GREAT LAKES INDIAN FISH AND WILDLIFE COMMISSION

Re: Discharge from PolyMet east pit at closure greater than previously reported

NorthMet EIS Co-lead Agency Project Managers:

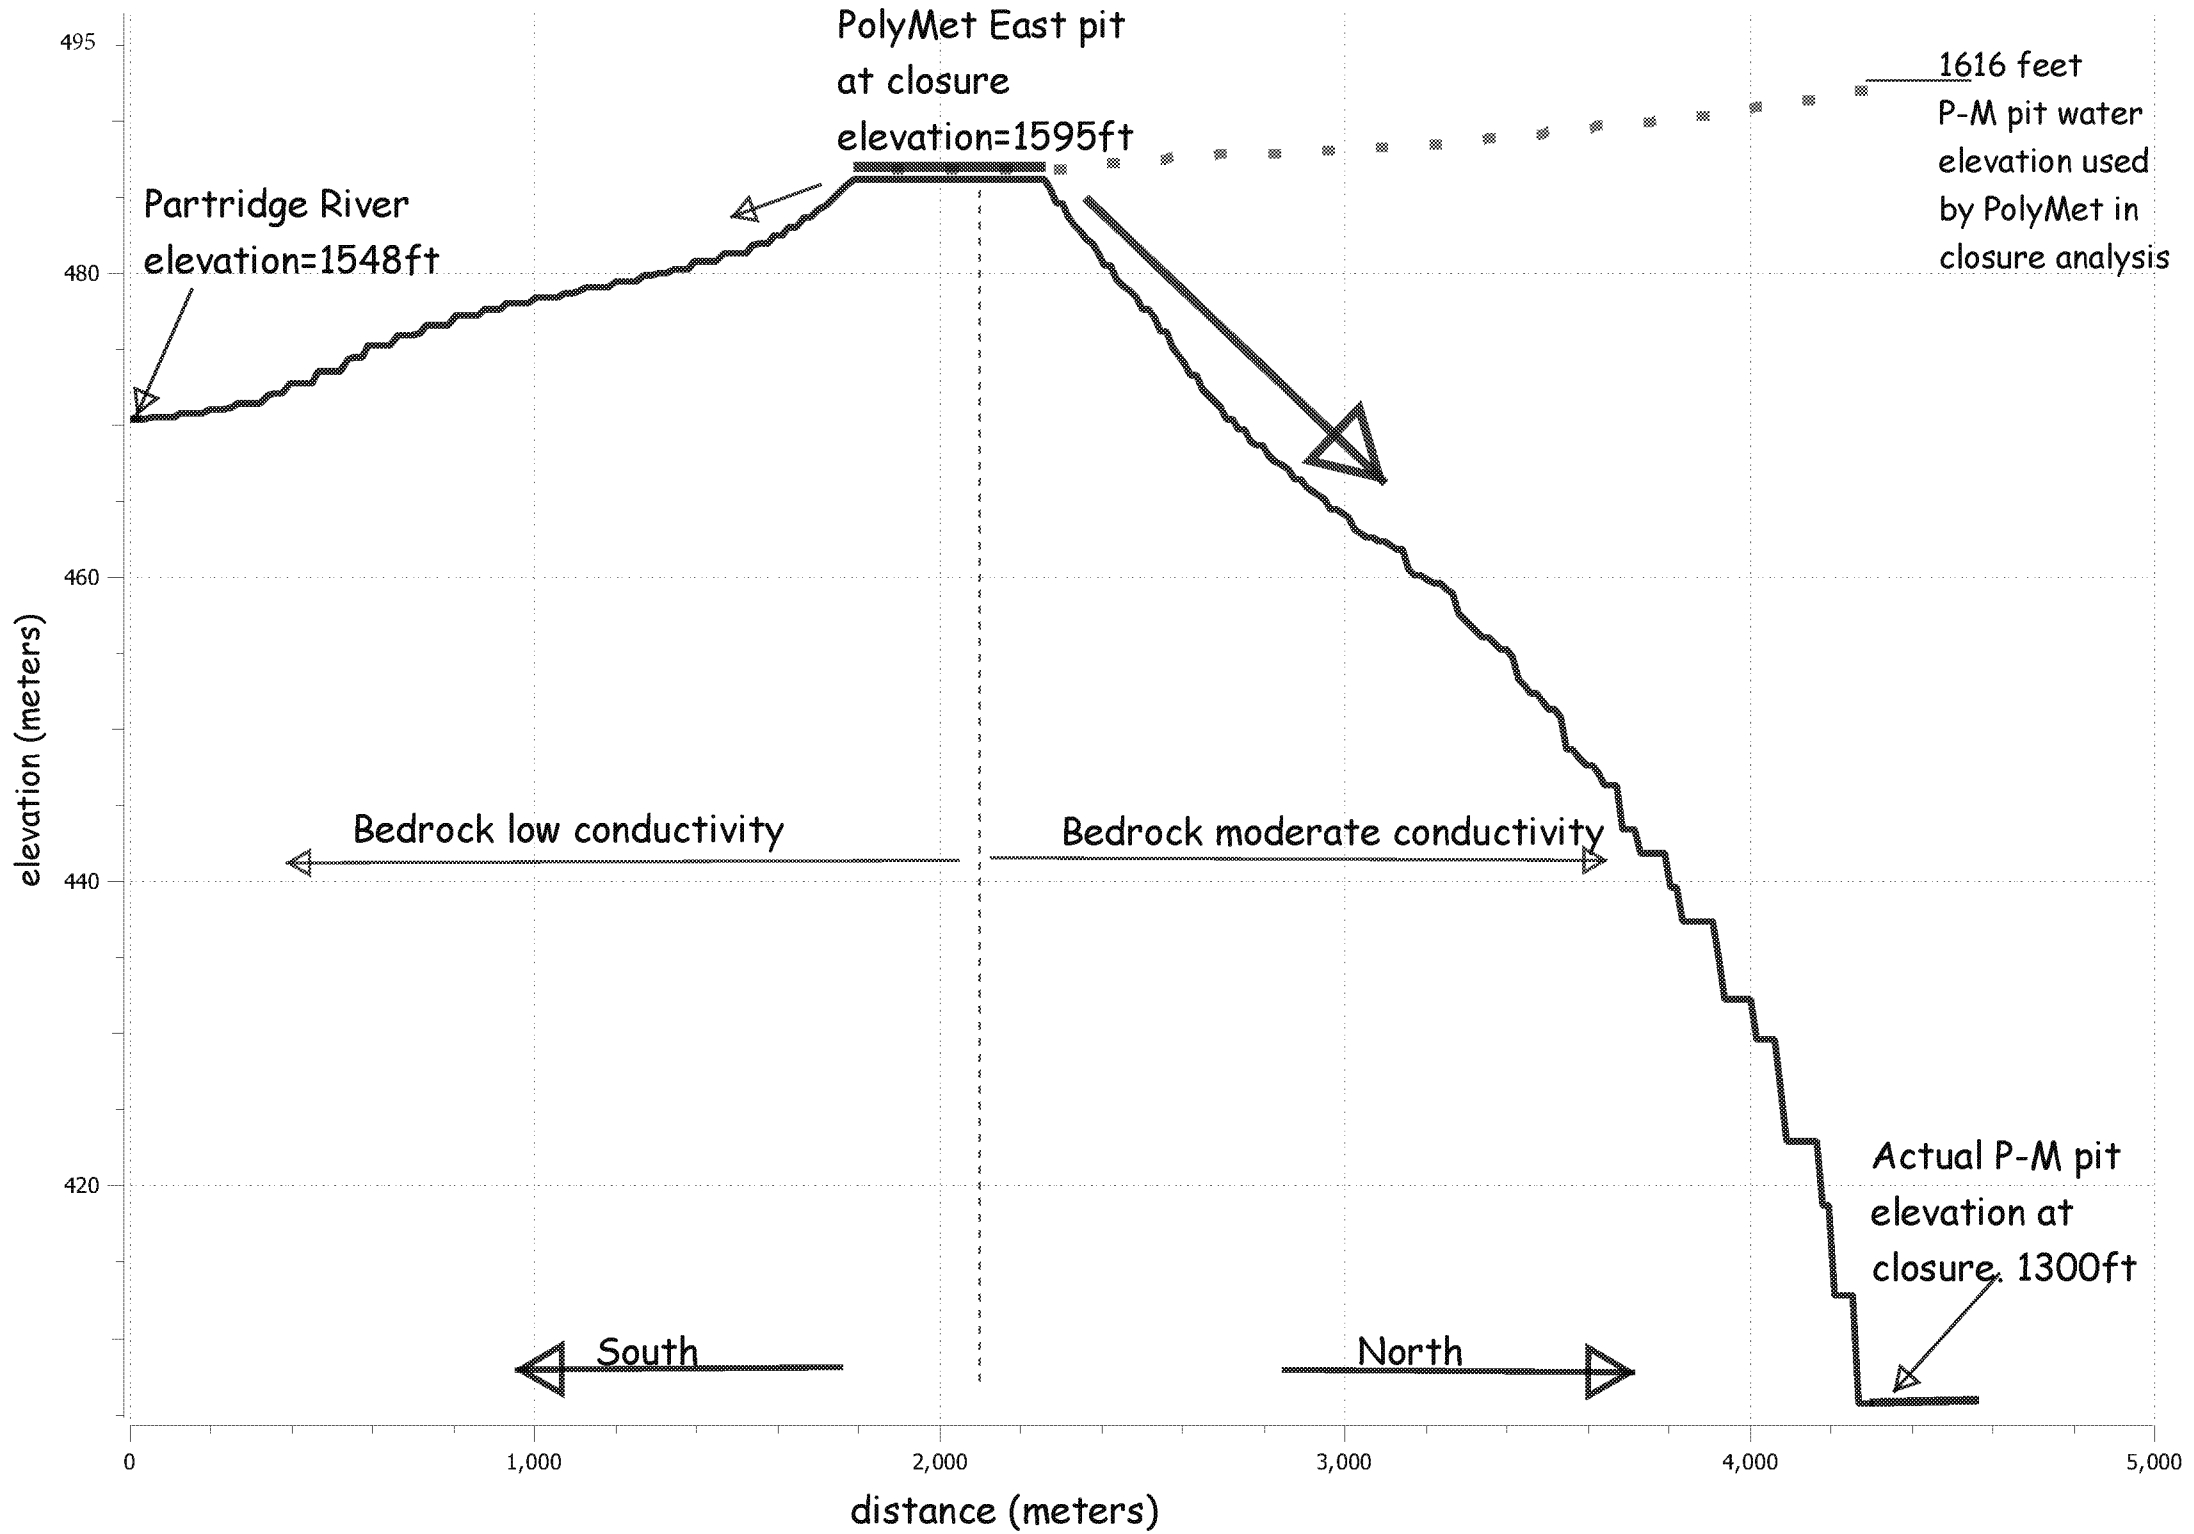
Both common sense (strong gradient to the north and more conductive bedrock to the north) and modeling, suggest that a substantial portion of the contaminants leaving the PolyMet east pit will move north in the post-closure period (see attached figure). Please note that because the mine pits are both deeply excavated into the bedrock but natural lakes are generally underlain with a lakebed, arguments related to the presence of Argo or other pit-side lakes are not hydrologically relevant to this issue; The connection between the PolyMet pits and the P-M pits is primarily through the relatively high conductivity Virginia Formation and Biwabik Iron Formation bedrock.

Our recent water budget analysis using the USGS utility ZoneBudget indicates that approximately 90% of the water leaving the 1595 foot elevation PolyMet east pit will travel north in bedrock toward the Peter-Mitchel pits when the P-M pits are at their correct closure elevation (1300 feet). Because of the 295 foot greater head pressure of the closed PolyMet east pit compared to the P-M pits and the relatively high conductivity of the Virginia and Biwabik Iron bedrock formations, it is not surprising that the majority of water leaving the PolyMet east pit would flow north.

Preliminary water budget analysis indicates that approximately 300 gpm will exit the PolyMet east pit through bedrock post-closure, when the P-M pits are at 1300 feet. This is in contrast to the total of 10 gpm that Barr Engineering estimated using the same mine pit inflow/outflow model but with P-M pit water elevations that were 316 feet too high (see attached figure). Contaminant transport analysis that accounts for approximately 300 gpm rather than 10 gpm of east pit groundwater discharge is likely to generate different conclusions for water quality at points of compliance.
